Z-45
(2017)

BURNT
HICKORY
Cobb, Georgia
Tishon Norman
DATE: 01-11-2017
SITE PLAN
Z1.00

PETITION NO: Z-45

ZONING COMMENTS:

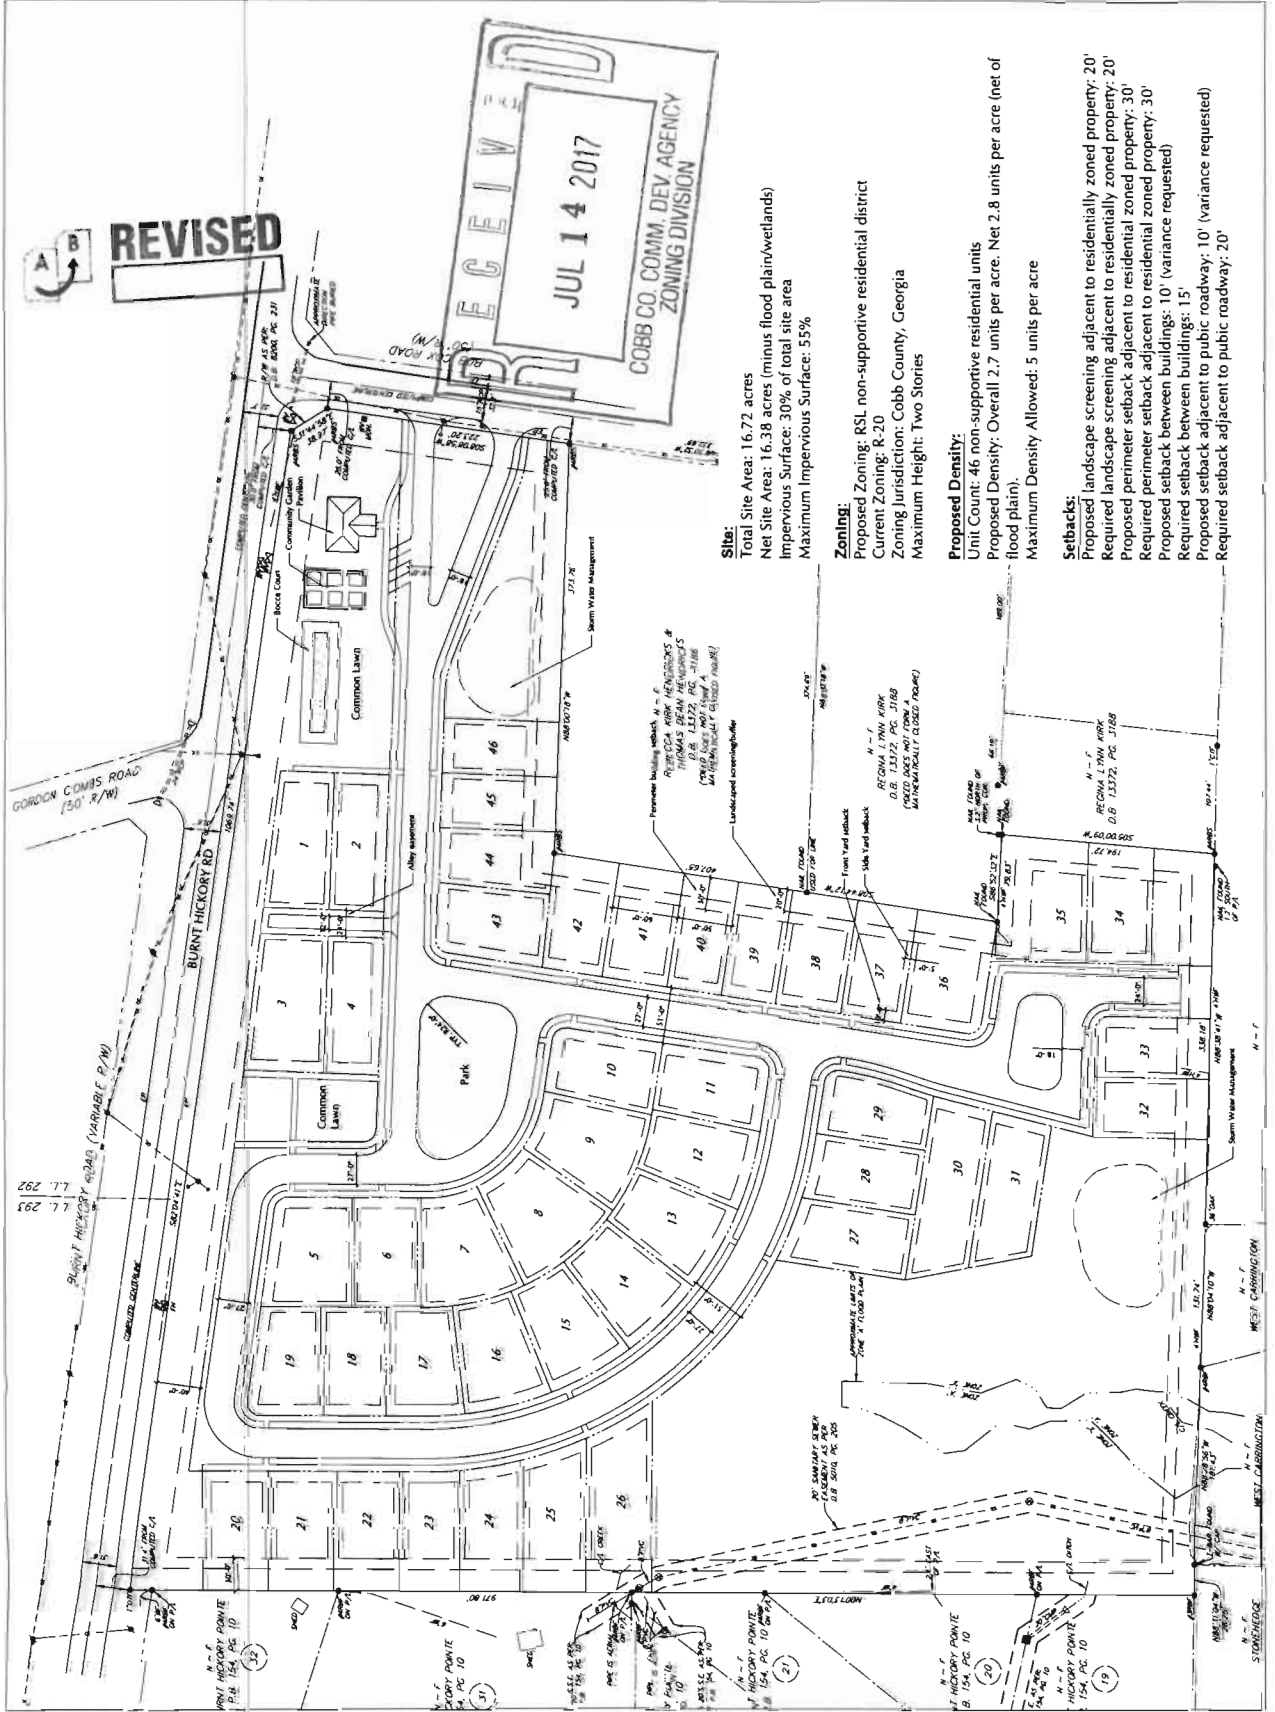
Moreover, the Code calls for RSL nonsupportive residential developments to be compatible with neighboring residential uses. While there is no minimum lot size required for RSL developments, the Code specifies a maximum density of five (5) units per acre (upa) which may be reduced by the Board when necessary. With a proposed 2.8 upa (net of floodplain/wetlands), the development is less than the max of five (5). However, the aforementioned variances may be indicative of an attempt of creating a development with more units than is reasonable for the site.

Certainly, the proposed 2.8 upa is more than those communities in the immediate area. To the south, West Carrington Unit II contains 36 lots at a density of 2.19 upa. Burnt Hickory Pointe to the west has 32 lots for a density of 1.71 upa, a number that is only half of the applicant’s proposal. Furthermore, Chimney Hollow Subdivision located to the north contains 10 lots at an even lower 1.2 upa. Ranging from 1.2 upa to 2.19 upa, the surrounding neighborhoods are much less dense that the applicant’s proposal of 3.5 upa.

- FEMA Designated 100 year Floodplain Flood.
- Flood Damage Prevention Ordinance DESIGNATED FLOOD HAZARD.
- Project subject to the Cobb County Flood Damage Prevention Ordinance Requirements.
- Dam Breach zone from (upstream) (onsite) lake - need to keep residential buildings out of hazard.

- Provide comprehensive hydrology/stormwater controls to include development of out parcels.
- Submit all proposed site improvements to Plan Review.
- Any **spring activity** uncovered must be addressed by a qualified geotechnical engineer (PE).
- Structural fill _____ must be placed under the direction of a qualified registered Georgia geotechnical engineer (PE).
- Existing facility.
- Project must comply with the Water Quality requirements of the CWA-NPDES-NPS Permit and County Water Quality Ordinance.
- Water Quality/Quantity contributions of the existing lake/pond on site must be continued as baseline conditions into proposed project.
- Calculate and provide % impervious of project site.
- Revisit design; reduce pavement area to reduce runoff and pollution.

2. The existing downstream subdivisions are older and have limited stormwater conveyance capacity with numerous drainage issues and complaints. As a result, it is recommended that stormwater management be elevated such that each storm discharge is controlled not to exceed the allowable discharge of the next lower, more frequent storm event (ie. 5-year storm event released at 2-year rate; 10-year event at 5-year rate; etc. to 100-year event at 50-year rate).

4. There is an existing, critical channel erosion issue immediately downstream of the site. The increased runoff volume from this development will likely exacerbate this situation. If this development is approved, it is recommended that channel stabilization measures be installed as part of the development to protect the channel and existing residential structure from adverse impacts.

Recommend relocating entrance on Burnt Hickory Road further west to allow construction of a full length left turn lane at the entrance. Recommend access on Burnt Hickory Road include a deceleration lane and left turn lane. Recommend location and design be determined during plan review, subject to Cobb County DOT approval.

Recommend access on Bob Cox Road include a deceleration lane and left turn lane. If a left turn lane cannot be added due to geometric restrictions, recommend access be restricted to right-in/ right-out. Recommend location and design be determined during plan review, subject to Cobb County DOT approval.

Recommend the proposed gate be a minimum of 50' from the right-of-way and meet Cobb County Development Standards.

1. Maximum density of 2.5 units per acre net of any floodplain/wetlands;
2. Final site plan to be approved by the District Commissioner;
3. Landscape plan to be approved by the District Commissioner;
4. Fire Department comments and recommendations;
5. Sewer and Water Division comments and recommendations;
6. Stormwater Management Division comments and recommendations;
7. Department of Transportation comments and recommendations; and
8. Owner/developer to enter into a Development Agreement pursuant to O.C.G.A. §36-71-13 for dedication of system improvements to mitigate traffic concerns.
